CITY OF BLOOMINGTON

June 26, 2013 @ 2:00 p.m.
CITY HALL -
KELLY CONFERENCE ROOM #155

**BLOOMINGTON HEARING OFFICER
STAFF REPORT**

**CASE #: V-27-13
DATE: June 26, 2013**

V-30-13
Site Plan

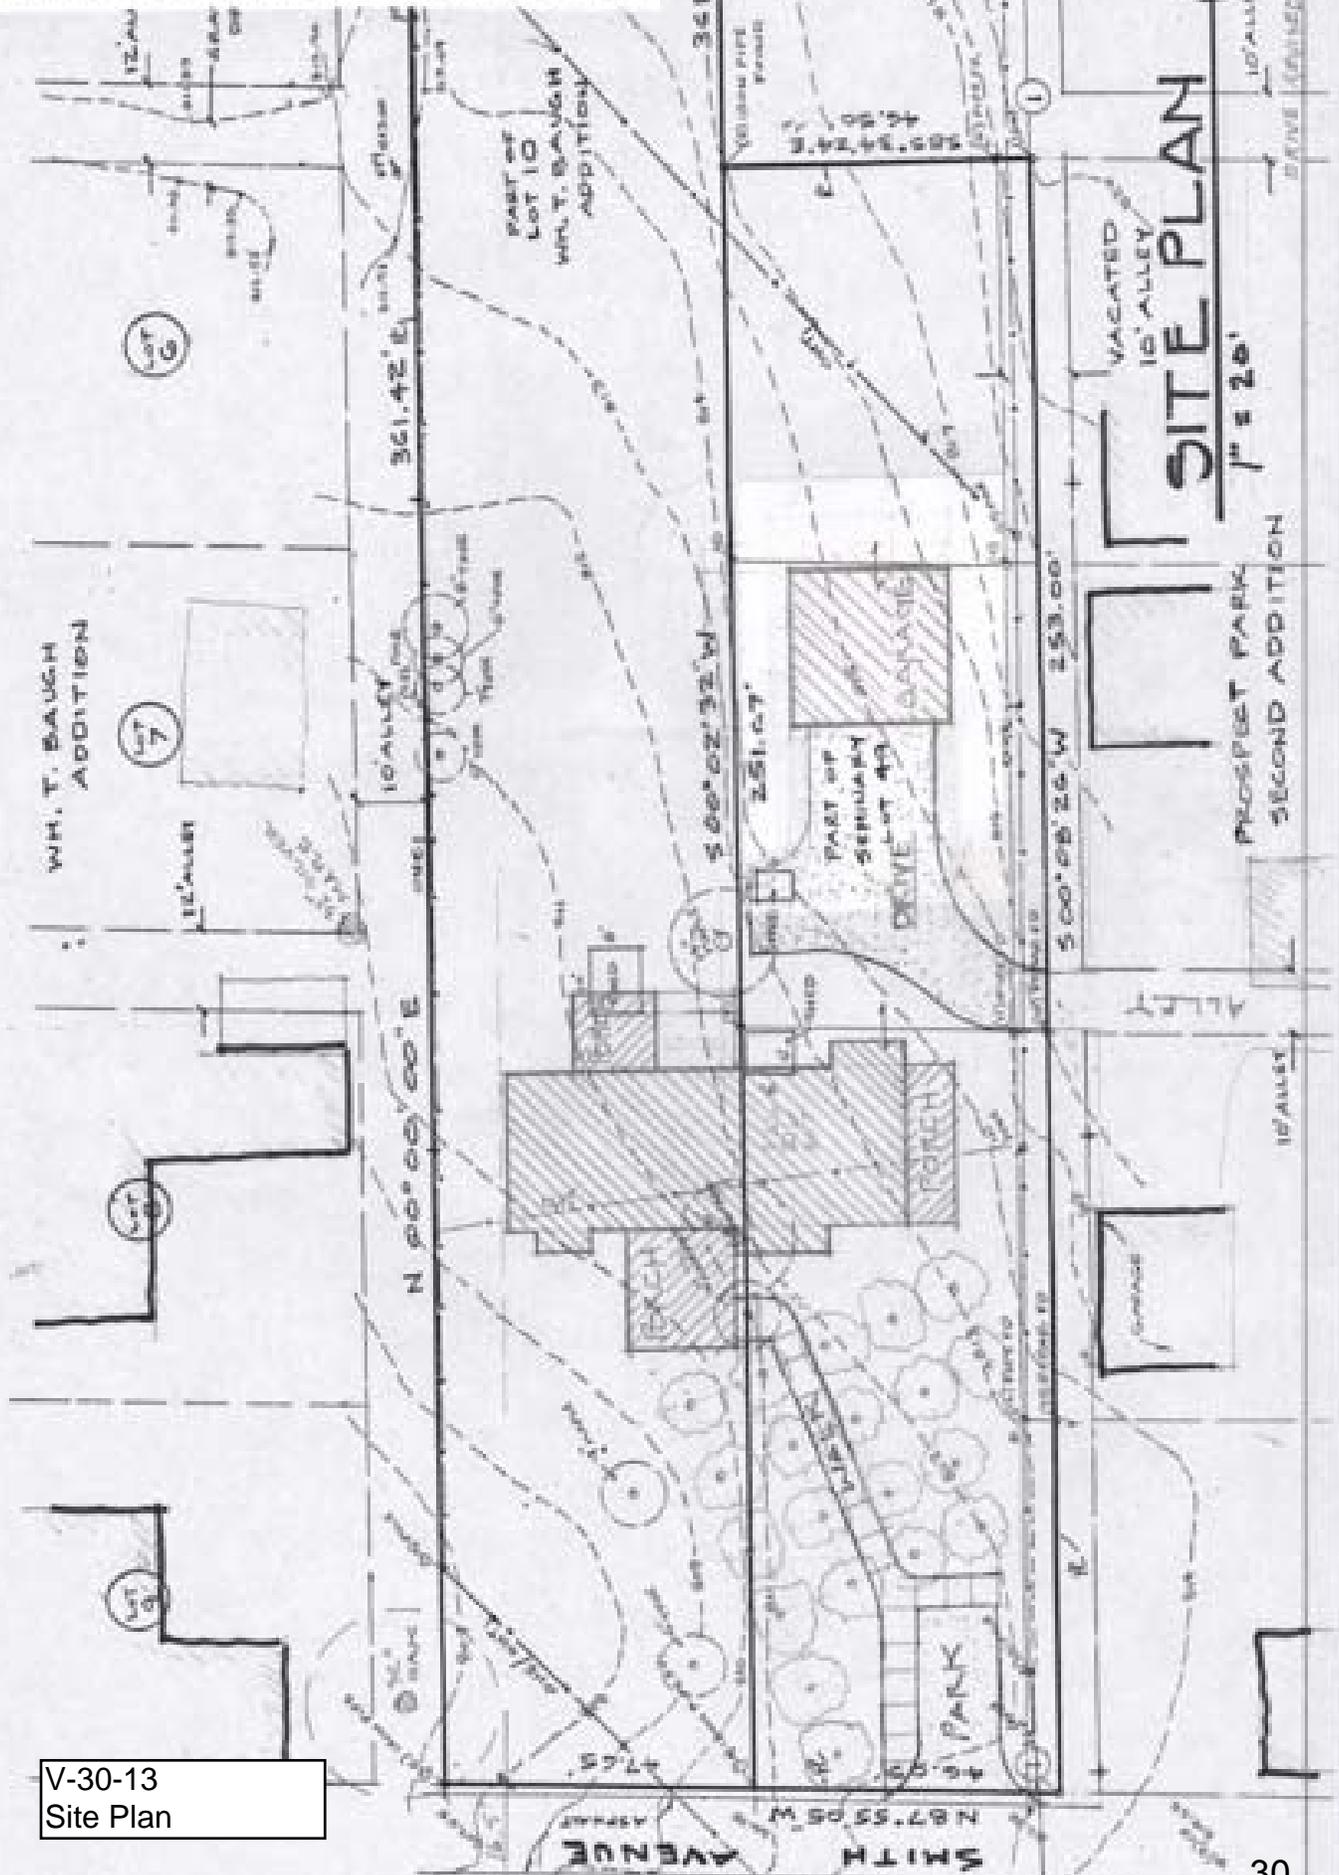
Variances are required for three aspects of the project. The first is the build-to line along Smith Ave. The UDO would require the home to be built approximately 2 feet from the Smith Ave. right-of-way. The proposal is a front setback of approximately 68 feet. The second is a variance from driveway requirements. The UDO only permits a driveway off of an alley and requires that it be not more than 20 feet wide. This variance will allow a secondary drive off of Smith Ave. and a turn-around addition to the drive into the garage. The third is the sidewalk construction requirements. The petitioners are requesting to not construct a sidewalk on Smith Ave.

STAFF FINDING: Staff finds peculiar condition in the existing pattern of houses along Smith Ave. This block of Smith Ave. has been developed more like an alley than a street. The right-of-way is only 15 feet wide. Houses on the south side of Smith Ave. front on Howe Street and have garages that access Smith Ave. The houses to the immediate east and west of the subject property face Euclid Ave. and Buckner St. respectively. These houses sit within 2 feet of Smith Ave. and set the build-to-line for this lot. Staff finds practical difficulty in requiring the petitioner to build their house 2 feet from the Smith Ave. right-of-way. There is not an established pattern on this block of houses facing Smith Ave. This shallow of a setback would create undesirable views from the proposed house of the rears of houses and garages on Smith Ave. A deeper setback does not detract from the pattern of the block because the pattern of this block is more similar to that of an alley than a street. The deep setback is requested to allow for southern exposure for

Staff finds peculiar condition in the narrow width of Smith Ave., the reduced right-of-way, and the lack of street parking. Most other streets in the RC zoning district have on-street parking or are wide enough to allow for temporary on-street parking. Staff finds practical difficulty in not allowing the proposed second driveway onto Smith Ave because without this driveway, visitors, emergency services or delivery vehicles would need to block Smith Ave. or park in the next block to access the house. Staff finds peculiar condition for the rear parking turn-around area because the lot is accessed

through an alley that is perpendicular to the lot, not parallel with it. The turn-around is necessary to allow the petitioners' vehicles to exit the garage and turn facing the alley so that they are not required to back down the alley to Euclid Ave..

Staff Finding: The adjacent parcels are developed, but have been built with houses within 4 feet of the edge of pavement of Smith Ave. which would make sidewalk construction impossible without narrowing of the already narrow street.

Staff Finding: Construction of a sidewalk on Smith Ave. should be delayed until such time as it is feasible to extend the sidewalk to the east to Euclid Ave. or to the west to Buckner St. Presently the close proximity of the houses and garages to the east and west, within 4 feet of the edge of pavement, make extending this sidewalk system impossible.

RECOMMENDATION: Based on the written findings above, staff recommends approval of V-30-13 with the following conditions.

1. Prior to release of a building permit, the petitioners shall execute and record a zoning commitment which states that a determinate sidewalk variance has been approved, and at some time in the future a 5' wide concrete sidewalk may be required.
2. A right-of-way excavation permit is required prior to construction of the driveway. A concrete apron is required adjacent to the street edge of pavement.
3. This project is subject to all terms and conditions of Certificate of Appropriateness #COA-9-13, approved by the Historic Preservation Commission on June 13, 2013.
4. Any gravel or crushed stone parking or drives must be contained via raised permanent edging material.
